Addendum No. 3

September 10, 2021

Project: San Fernando Regional Park Infiltration Project

**Attachment 4: Revisions to Diversion Pipe Plan and
Profile from Glenoaks Boulevard**

San Fernando Regional Park Infiltration Project
SAN FERNANDO RECREATION PARK AND FROM FIRST STREET TO GLENDALE BOULEVARD
LINE "B" STA 37+00 TO 41+00
PLAN AND PROFILE
DWG NO. C-08
SHEET NO. 9 OF 46

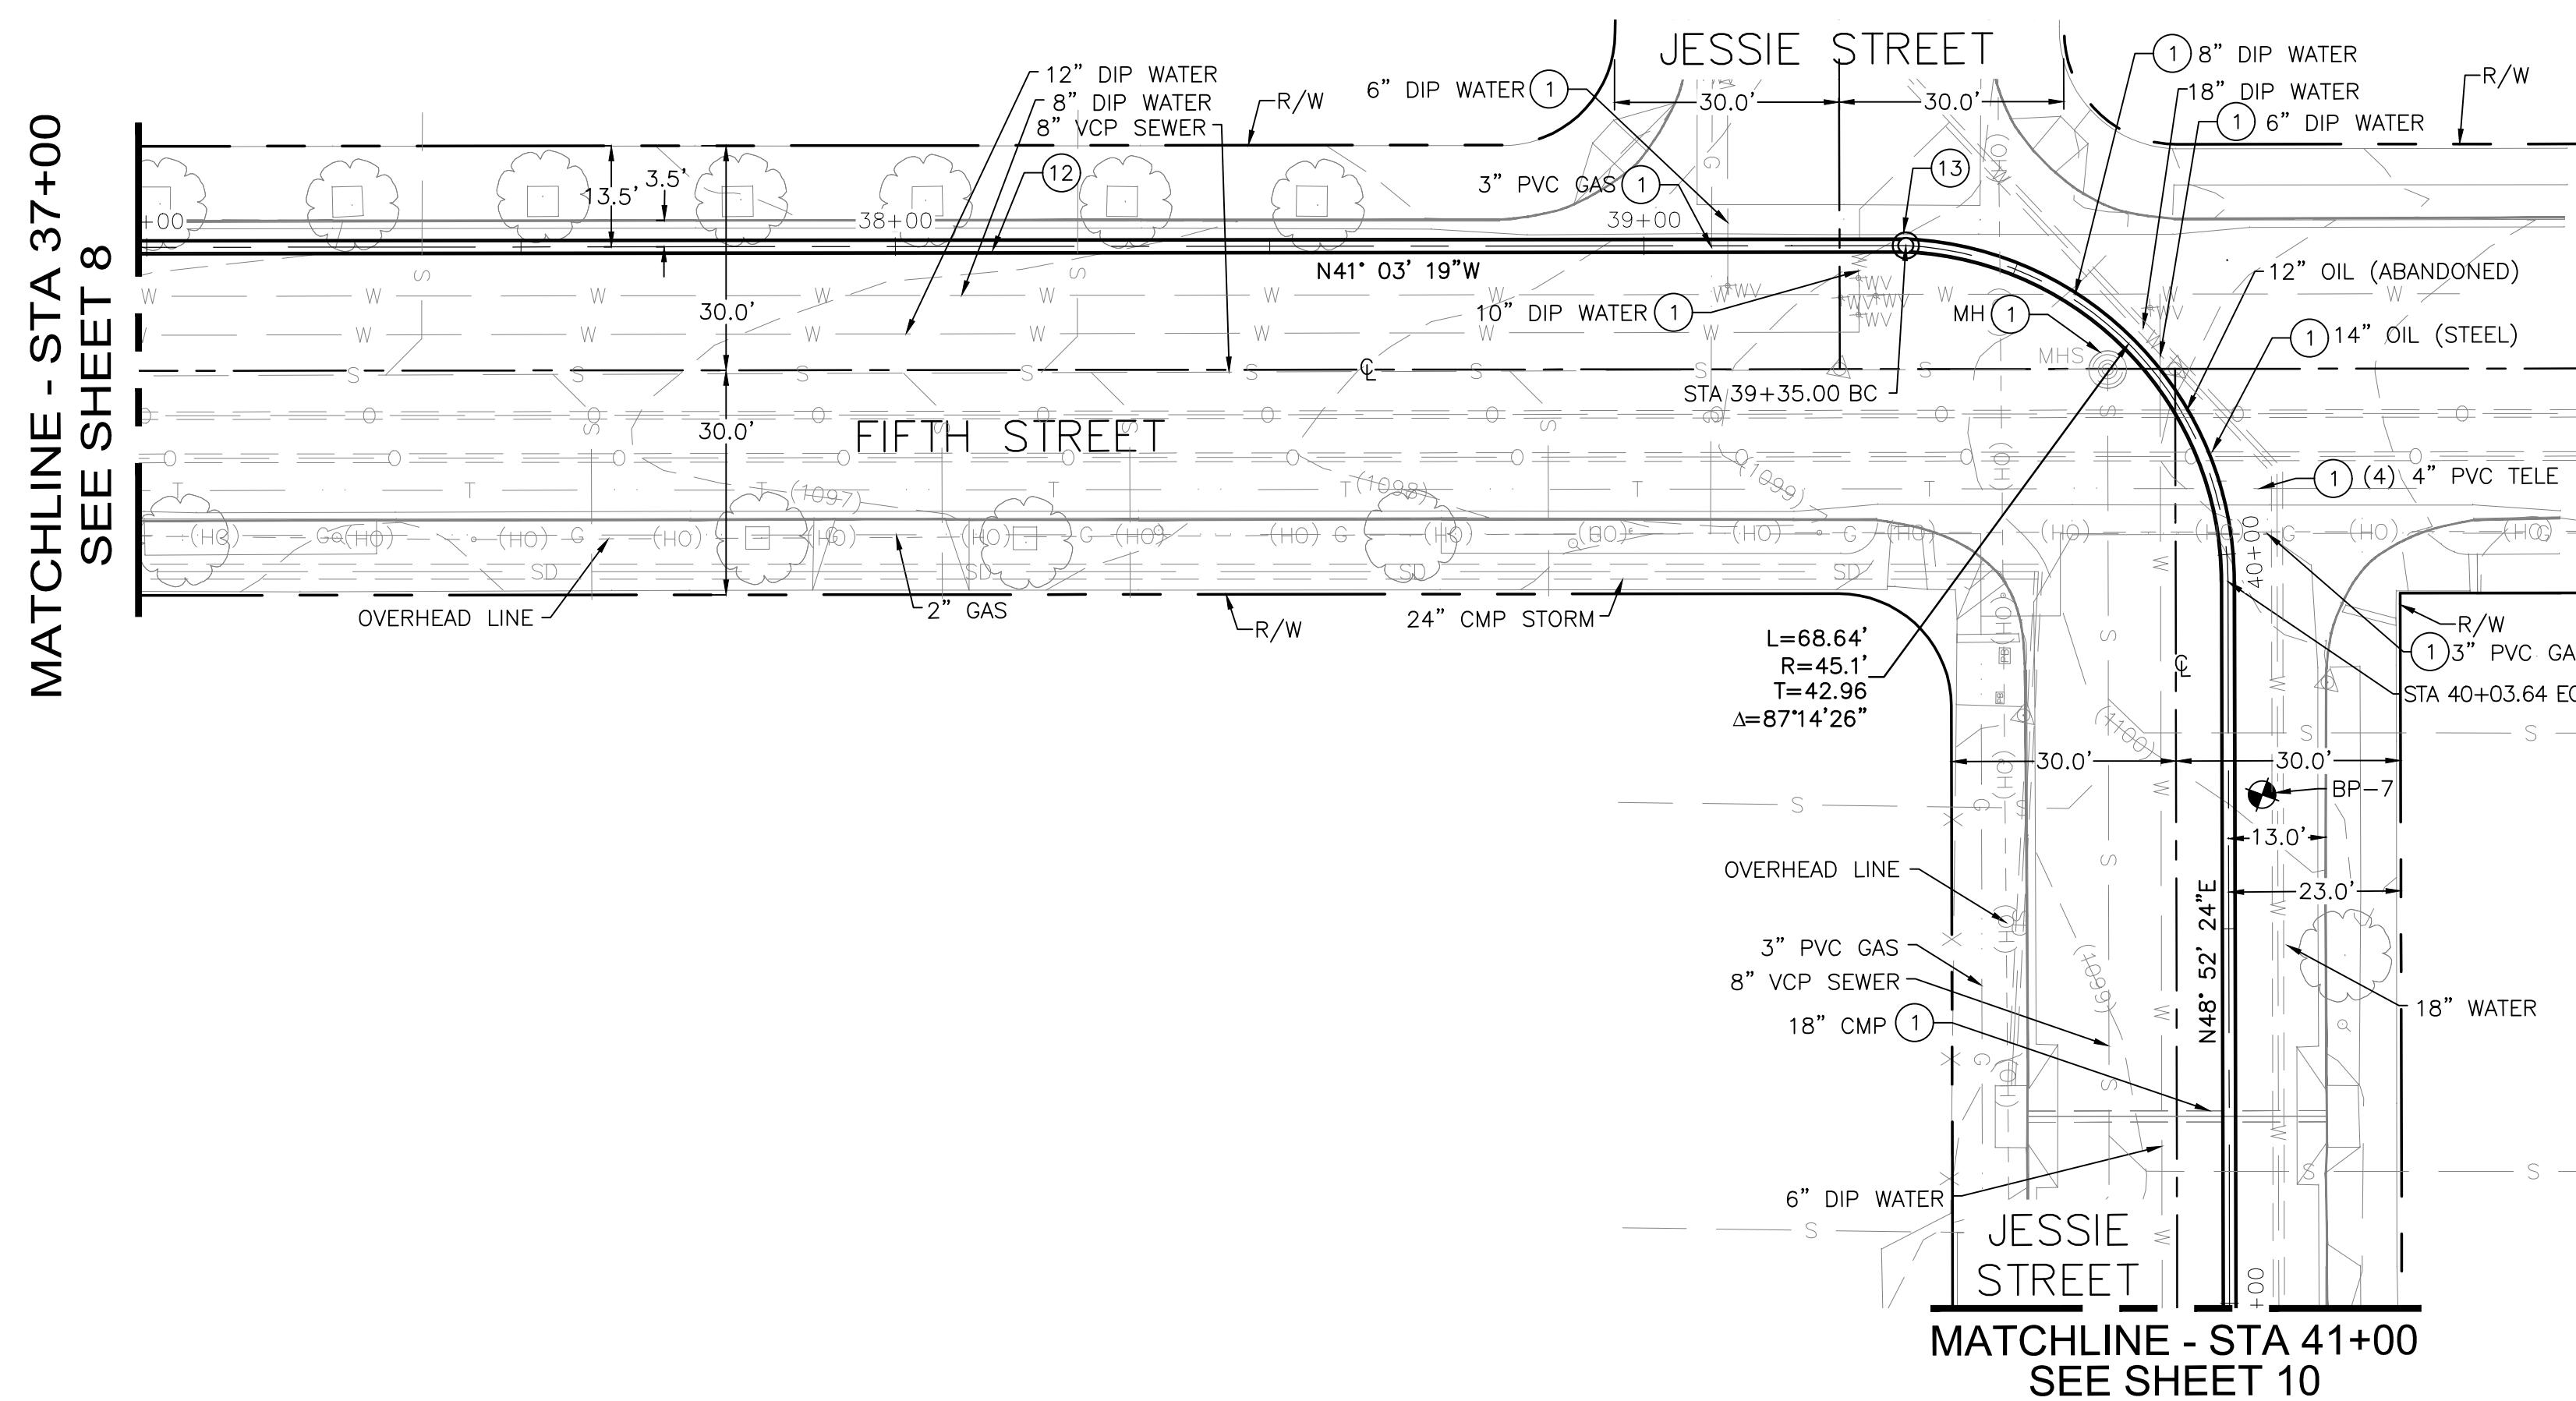
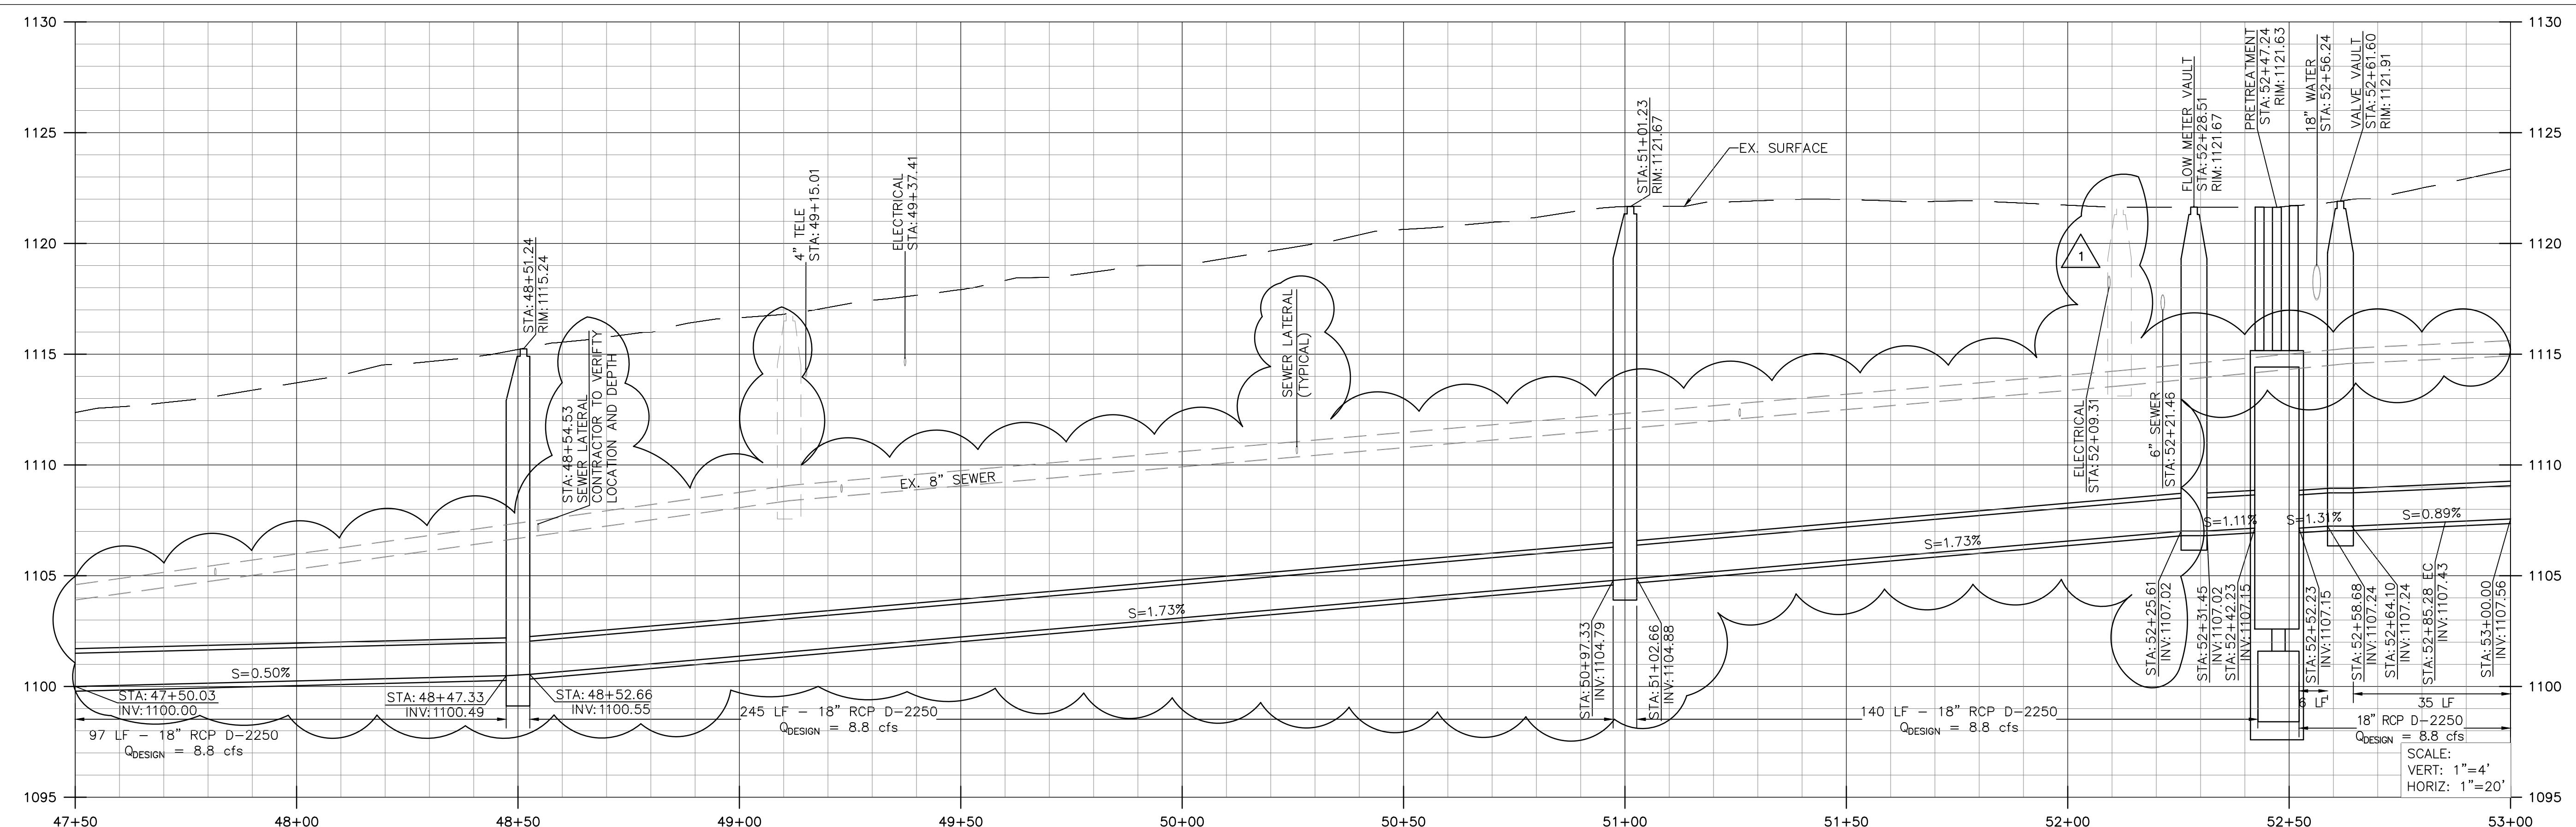
REV.	DATE	BY	DESCRIPTION	APP'D
1	9/7/21	TT	ADDED EX. SEWER LINE TO PROFILE; REVISED PIPE INVERT/SLOPE	
2	9/10/21	TT	ADDED HOUSE CONNECTION NOTE UNDER NOTES TO CONTRACTOR
